First amendment of the Day-Ahead Capacity Calculation Methodology of the Core Capacity Calculation Region

in accordance with article 20ff. of the Commission Regulation (EU)
2015/1222 of 24th July 2015 establishing a guideline on capacity allocation
and congestion management

16th November 2020

Explanatory document to the first amendment of the Day-Ahead Capacity Calculation Methodology of the Core Capacity Calculation Region

Figure 1: LTA Domain and Virgin FB Domain

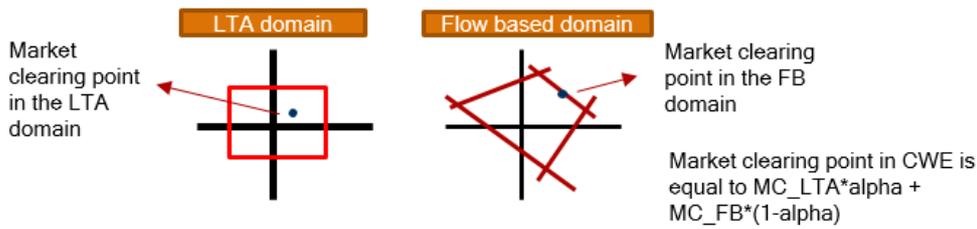
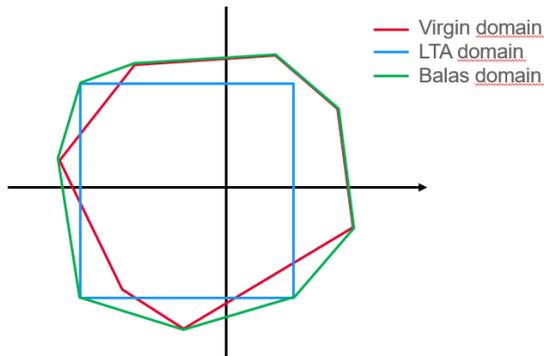
A R&D track under SDAC governance successfully elaborated an alternative way of doing the LTA inclusion directly in the market coupling algorithm EUPHEMIA, resulting in a much reduced time to first solution. This LTA inclusion approach is called "Extended LTA inclusion" for which EUPHEMIA expects as input from the capacity calculation process two separate domains representing the cross-zonal capacity, namely the virgin FB domain (minRAM included, without LTA inclusion) and the LTA domain. EUPHEMIA is allowed to choose which combination of both domains creates most social welfare in the SDAC. To perform this optimisation EUPHEMIA applies the so-called "Balas formulation" where the variable "alpha" represents the optimal share of the LTA domain (alpha) versus the optimal share of the virgin FB domain (1-alpha).

Please note that the "Balas domain" illustration in Figure 2 is added for educational purposes only as EUPHEMIA does not actually create such LTA included domain. Instead of the complex mathematical action of creating the union of the virgin FB domain and the LTA domain, EUPHEMIA "selects from" the two domains using the optimization variable alpha.

Figure 3: Virtual Branches approach (as currently performed in CWE) and LTA margin approach (as included in the Core DA CCM)

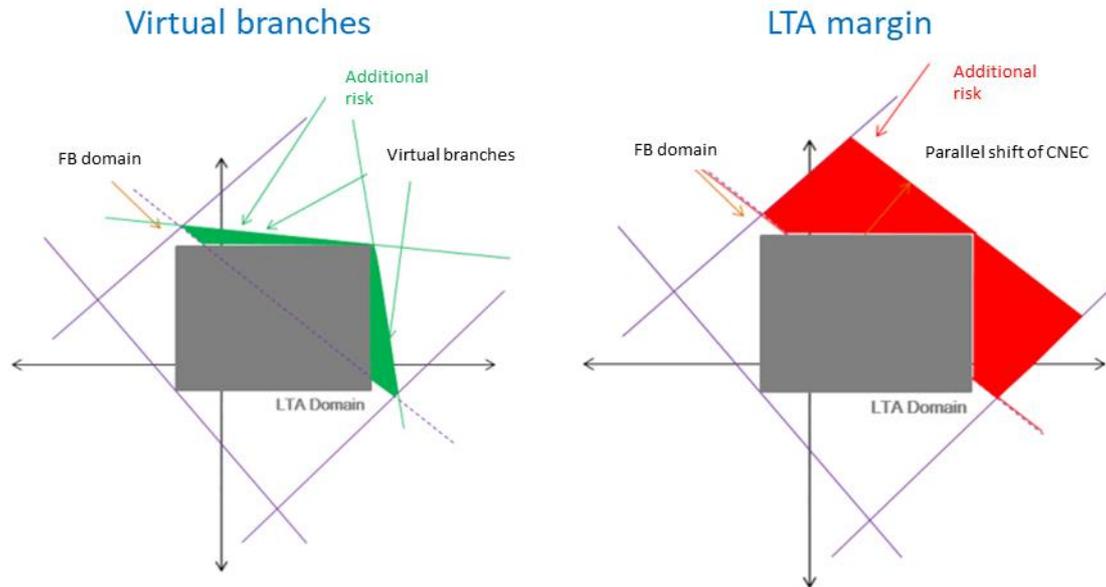
From a CCR Core perspective, the use of convex hull to perform LTA inclusion was considered during the alignment calls between Core TSOs and ACER before the final CCM was published. ACER saw the approach positively but it was left out of the Core DA CCM scope, because the solution discussed at the time (direct determination of convex hull) appeared infeasible. The Core DA CCM stipulates a rougher method for LTA inclusion, the LTA margin approach, which in comparison to the convex hull approach significantly increases the FB domain.

The development of the extended LTA formulation is considered very promising by the Core TSOs as it provides a more secure domain as a result due to less virtual enlargement compared to the current LTA margin approach, while still allowing market trades within the LTA Domain.

Figure 4: Main milestones of Core DA CCM implementation before October 2020

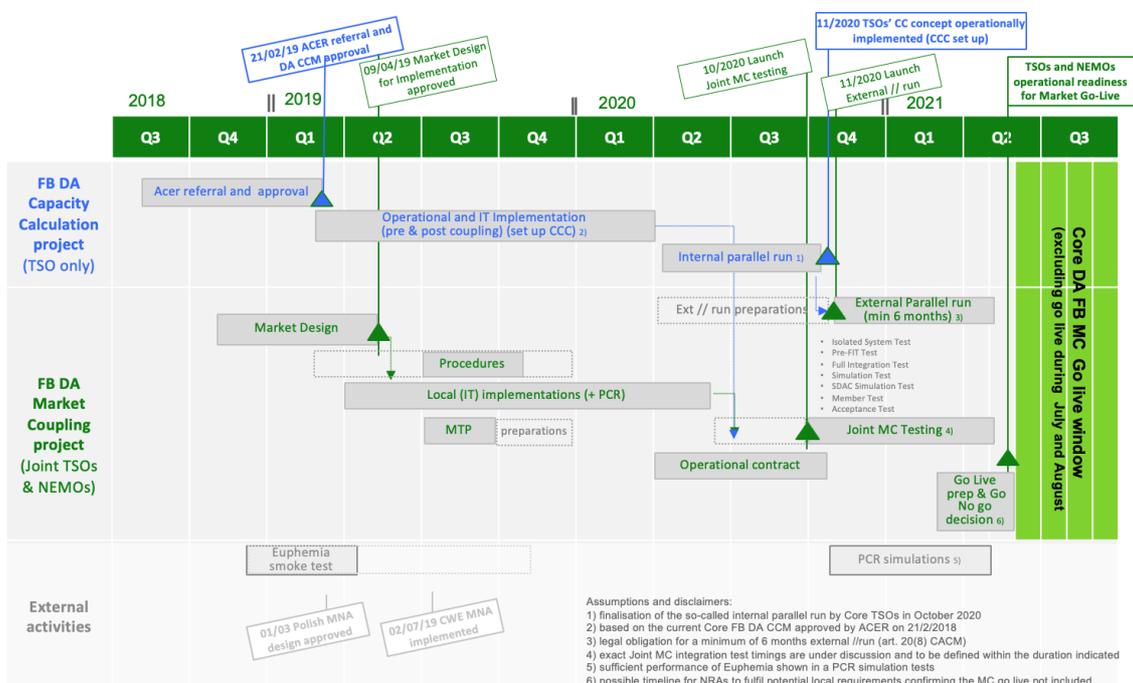
The planning and main milestones communicated to ACER, NRAs and MPs before October 2020 can be found below:

Core TSOs were convinced that the detailed planning as a result of a thorough impact assessment based on the final Core DA CCM and alignment with all parties that have to contribute to the implementation of Core FB DA CC is the only realistic approach to implement Core FB DA CC as soon as feasible and allow market parties to prepare themselves for its implementation.

Core TSOs therefore - in light of the confirmation letter of Core NRAs from 13th October 2020- propose to change the formal deadline in the Core DA CCM. The amended Article 28(3) of Core DA CCM to reflect the latest moment of the implementation following the aforementioned guidance to 28 February 2022, as the formal deadline for implementation of Core FB DA CC.
